## **ENVISION LEGACY SUBDIVISION**

APPLICATION NUMBER 7 DATE March 2, 2023

REQUEST Subdivision

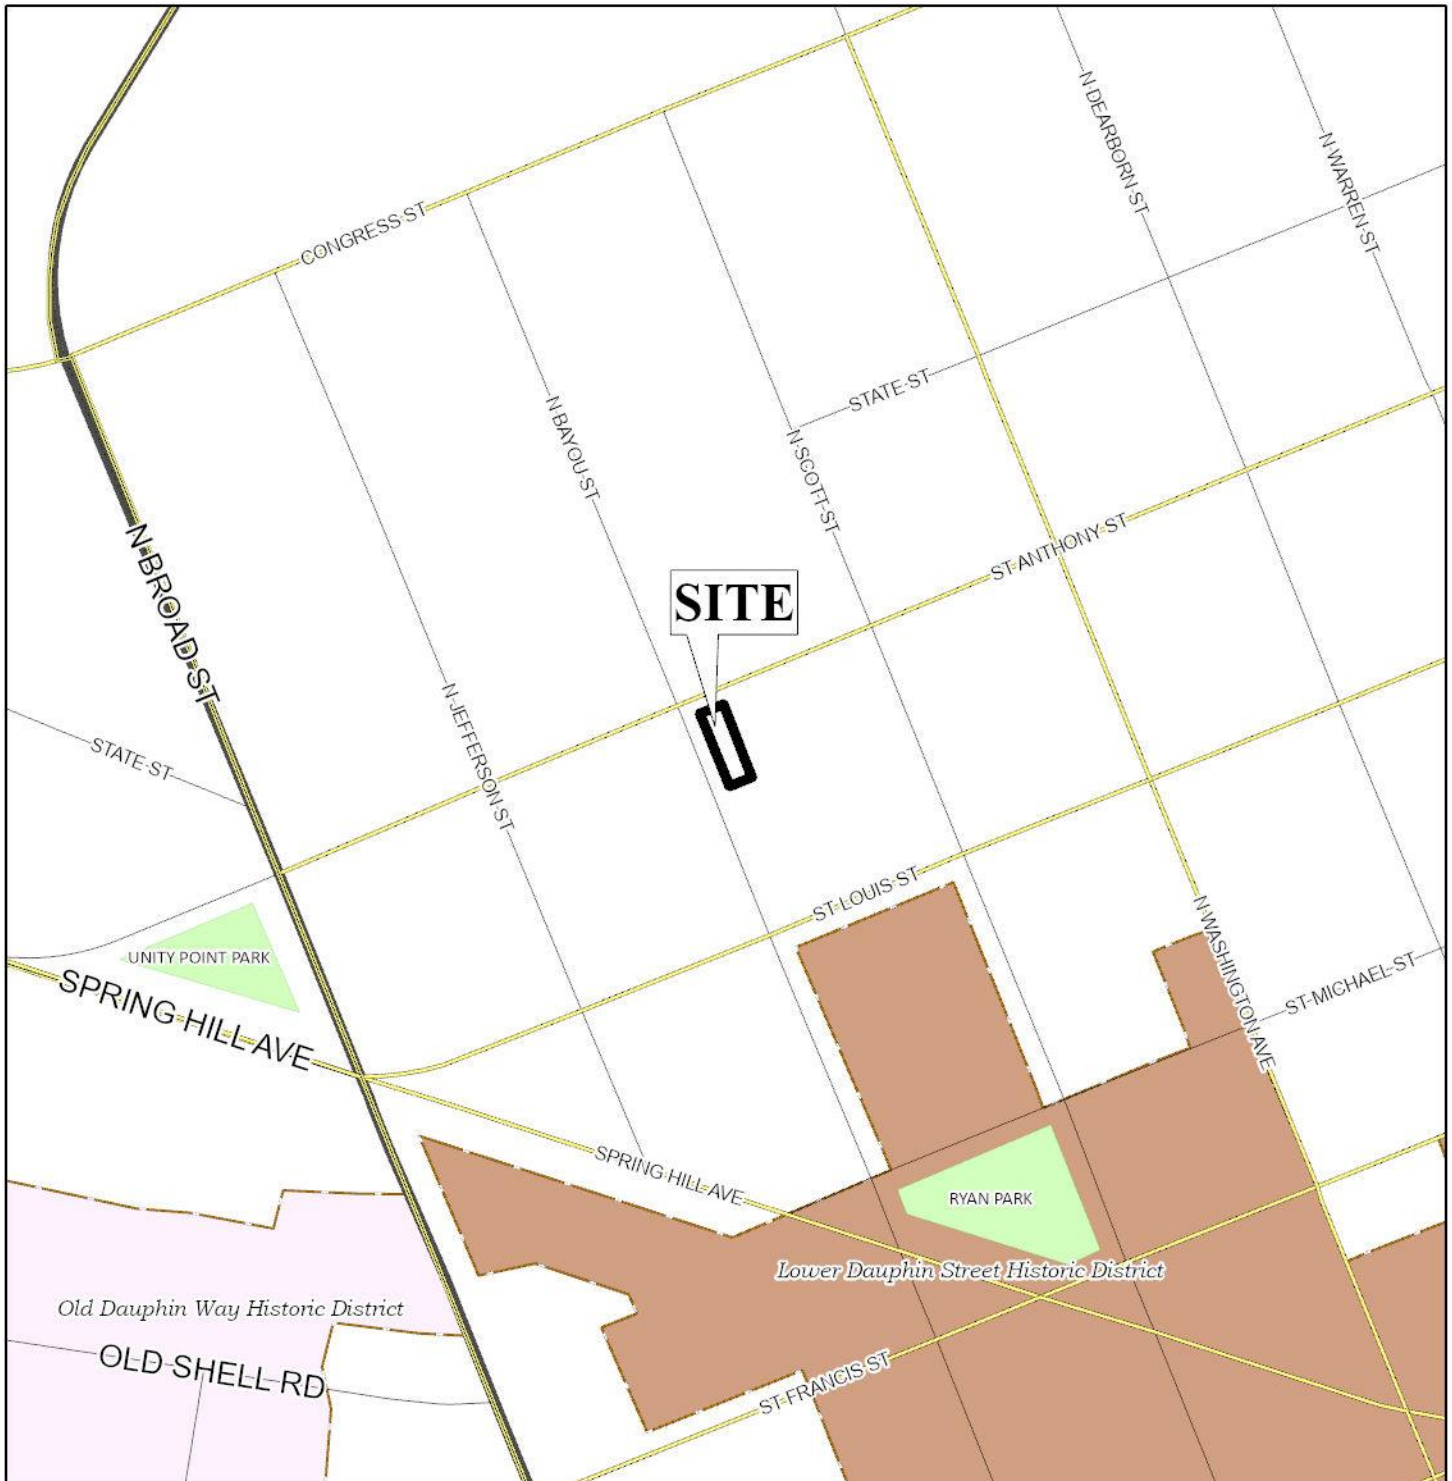
- B. Provide reference monuments for the two (2) corners on the property line between LOT 1 & LOT 2.
- C. Provide a detail of the two (2) corners on the property line between LOT 1 & LOT 2 showing the building corners.

- D. Show and label the MFFE (Minimum Finished Floor Elevation) on each lot that contains an A, AE, or X (shaded) flood zone designation. BFE = 11.
- E. Add a note to the SUBDIVISION PLAT stating that as shown on the 1984 aerial photo (FLIGHT 29 - #75) LOTS 1 and 2 will share the historical credit of existing (1984) impervious area towards stormwater detention requirement per Mobile City Code, Chapter 17, Storm Water Management and Flood Control) as follows: LOT 1 – 1,000 sf and LOT 2 – 700 sf.

Chapter 64-3.I.8.(a)(1) of the DDD requires that for properties that abut multiple frontages, the property owner shall designate one frontage as the primary frontage. If approved, a note should be placed on the Final Plat designating St. Anthony Street as the primary frontage for Lot 1. The DDD prohibits parking access from a primary frontage, when a secondary frontage is available. Furthermore, properties in a SD-WH sub-district are only allowed a driveway along a primary frontage, where there is no secondary frontage available, and the lot exceeds 54-feet in width. Proposed Lot 2 has only 38-feet of frontage, and thus is not allowed a curb cut. If approved, a note should be placed on the Final Plat stating this information.

The site fronts St. Anthony Street, a major collector street, and North Bayou Street, a minor street with curb and gutter. Both streets have existing compliant rights-of-way. If the Engineering Department determines it necessary, dedication of the curb radius, per Section V.D.6. of the Subdivision Regulations should be required.

The Subdivision Regulations require a minimum building setback of 25-feet along all public street frontages, whereas the DDD requires a 10-foot maximum setback along primary frontages in a SD-WH sub-district. If approved, Section V.D.9. of the Subdivision Regulations should be waived, with a note placed on the Final Plat stating that setbacks must comply with the underlying zoning district of the property.

The lot sizes are provided in square feet and acres, which do not comply with the minimum standards of Section V.D.2. of the Subdivision Regulations. The DDD only provides minimum and maximum lot widths, not overall square footage, and as such, a waiver of Section V.D.2. of the Subdivision Regulations may be appropriate. If approved, the lot sizes should be retained on the Final Plat, adjusted for any dedication.

- 1) dedication of the corner radius at St. Anthony Street and North Bayou Street, as deemed necessary and appropriate by the Engineering Department;
- 2) placement of a note stating that any re-development of the property must comply with the requirements of the Downtown Development District (DDD);
- 3) placement of a note designating St. Anthony Street as the primary frontage for Lot 1;
- 4) placement of a note on the Final Plat stating that setbacks must comply with the underlying zoning district of the property;

- 5) retention of the lot size in both square feet and acres, or the furnishing of a table on the Final Plat providing the same information, adjusted for any required dedication;

- 6) placement of a note stating that Lot 1 may only have a curb cut from St. Anthony Street;
- 7) placement of a note stating that Lot 2 is prohibited from having a curb cut;
